SHEET TITLE: CENTRAL FIRE STATION		SHEET TITLE: WALL ELEVATION @ COL. LINE N7	
HARRIS SHARP & ASSOC., INC. ARCHITECTURE-PLANNING-INTERIORS 2915 W. CHARLESTON BLVD. LAS VEGAS, NEVADA 89102 (702) 877-0125	JOB No. 482-1	DATE 3-28-83	SHEET No. Q-14
DRAWN H.S.	CHECKED H.C.

SHEET TITLE: CENTRAL FIRE SERVICES		SHEET TITLE: TOILET ROOM REVISIONS	
HARRIS SHARP & ASSOC., INC. ARCHITECTURE-PLANNING-INTERIORS 2915 W. CHARLESTON BLVD. LAS VEGAS, NEVADA 89102 (702) 877-0125	JOB No. 482-1	DATE 3-28-83	SHEET No. Q-18
DRAWN H.S.	CHECKED H.C.

Department of Public Works Engineering Design Division		CENTRAL FIRE STATION	
REVISIONS AND/OR CLARIFICATION		CENTRAL FIRE STATION	
Scale (h) Scale (v) W.A.		Scale (h) Scale (v) W.A.	
Fid. bk. no. Date		Fid. bk. no. Date	
Design by		Design by	
Drawn by		Drawn by	
Revisions		Revisions	
Date		Date

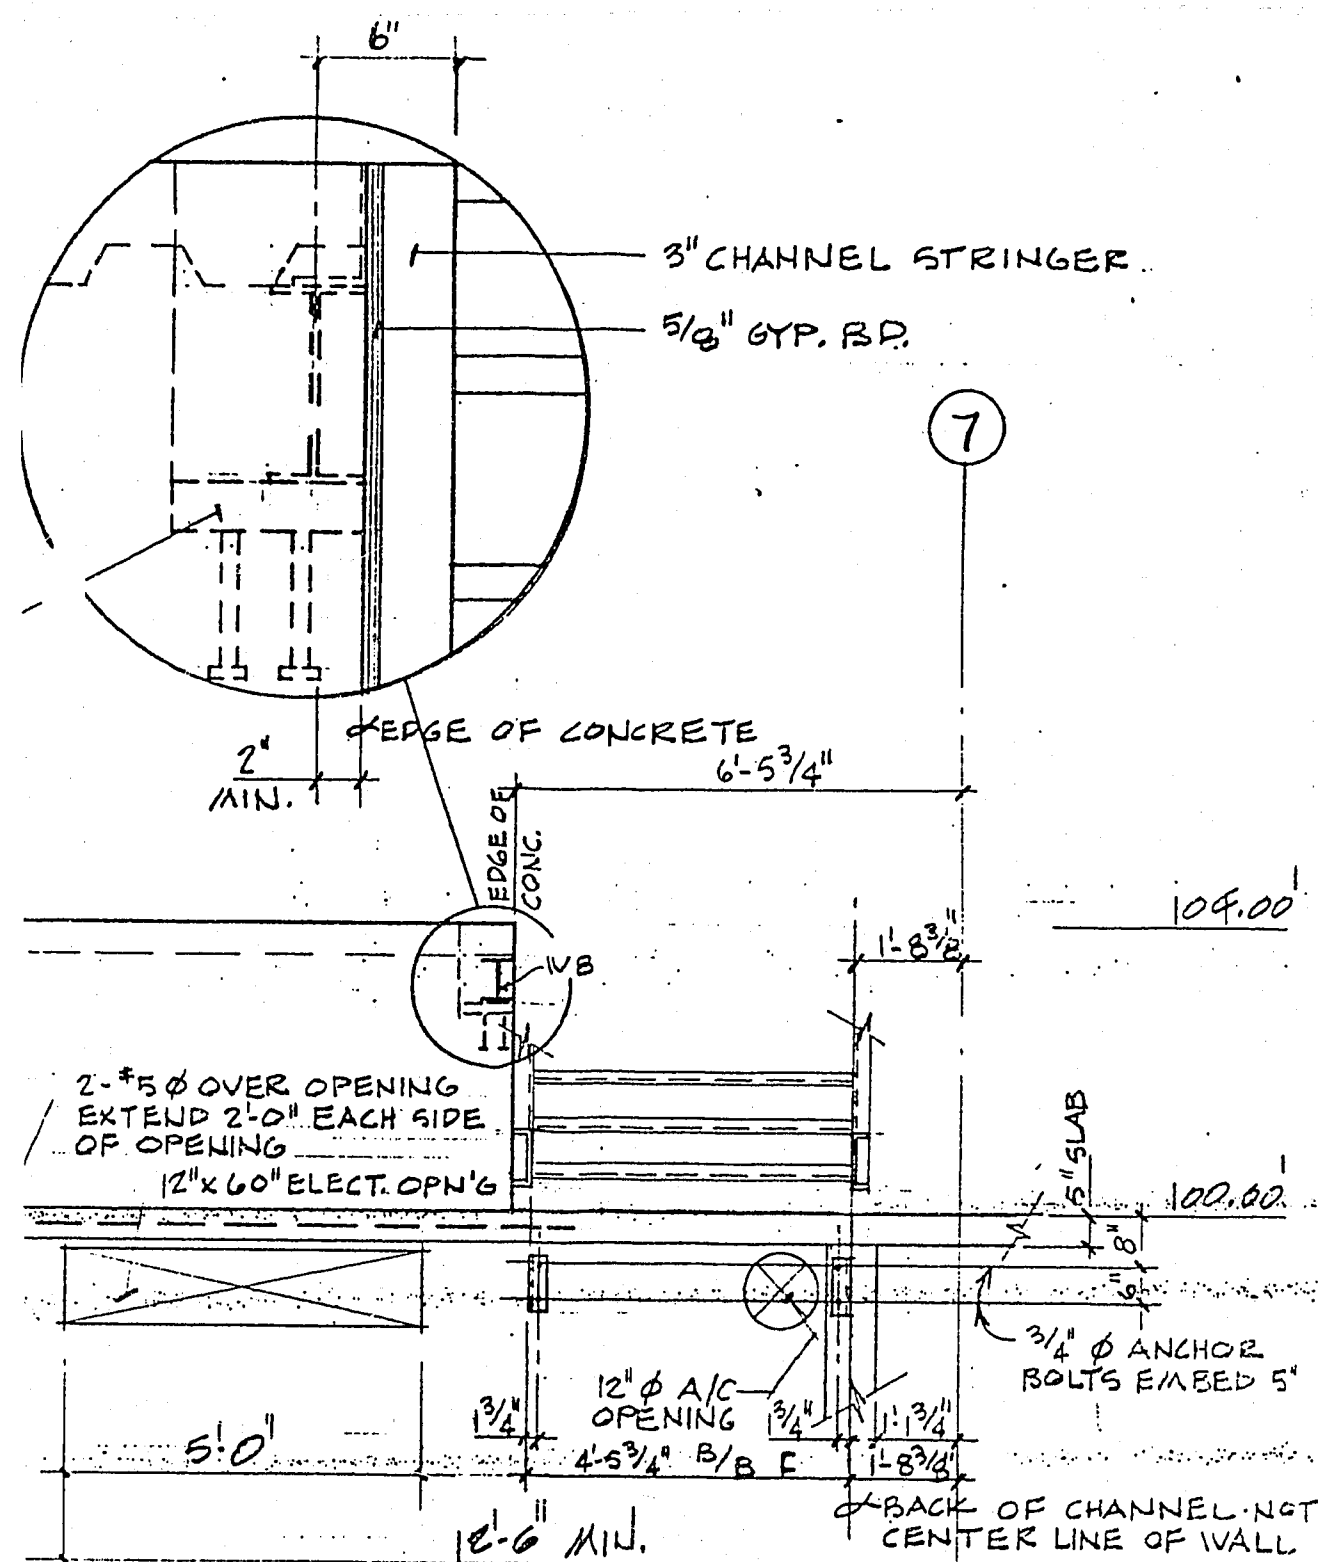
PENETRATIONS @ COLUMN LINE 'N' IN
 CONCRETE WALL (COMMUNICATIONS LEVEL)

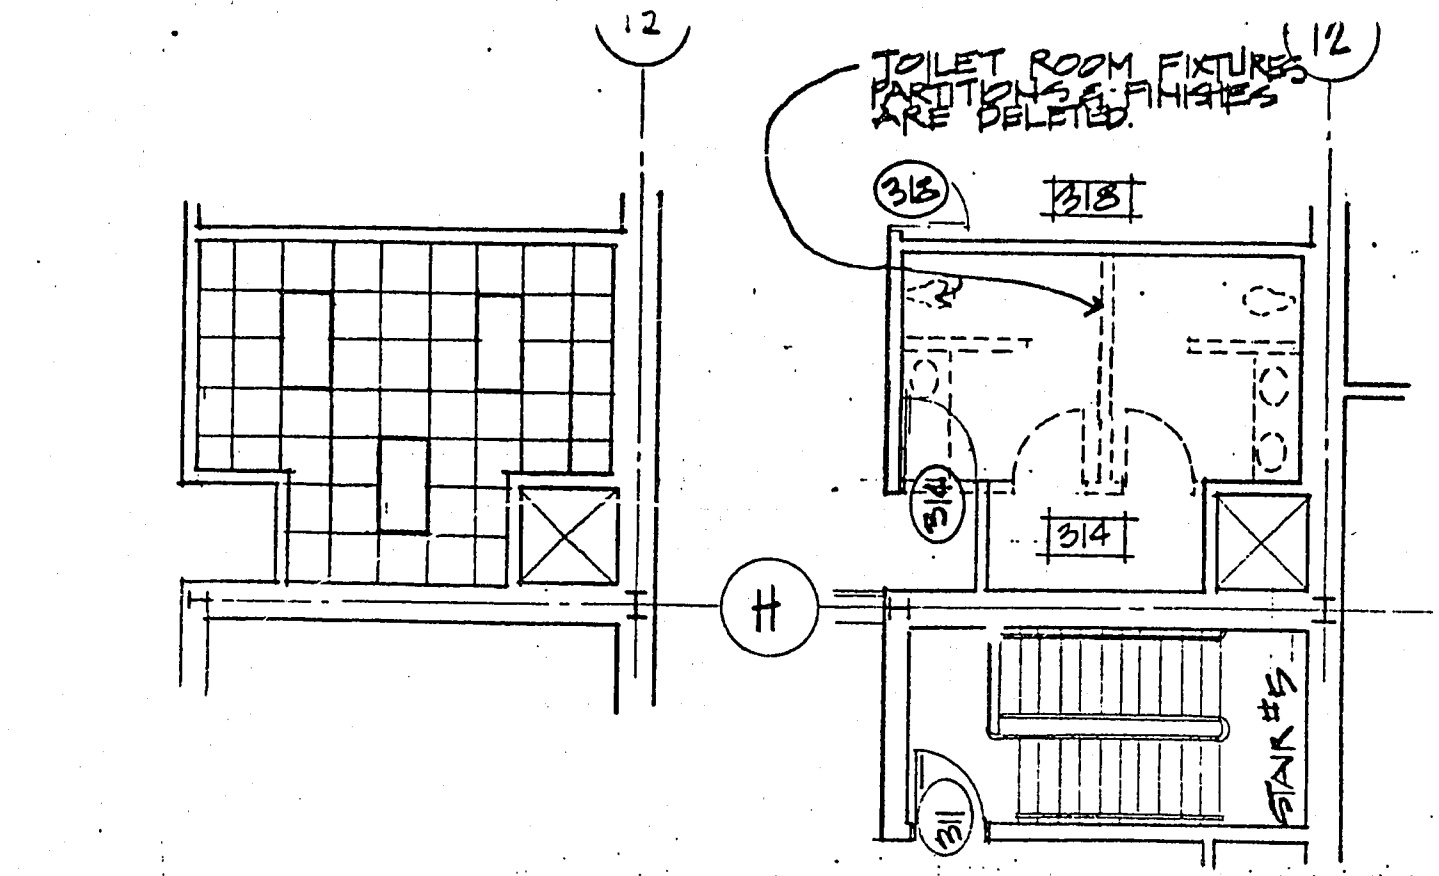
REVISED ROOM FINISH
 SCHEDULE 1

FLOOR - HOLLYTEX, GOLDEN GATE PARK 40, #B341-340 TOASTED ALMOND

CEILING - BURR ACOUSTIC TILE, ARMSTRONG CORTEGA PARCHMENT

WALLS - PAINT, AMERITONE #291 F - CEREAL

BASE - RUBBER, BURKE #602 P

NOTE -
 1. DOOR NUMBER 314 TO MATCH DOOR NUMBER 313, INCL. FINISH HARDWARE
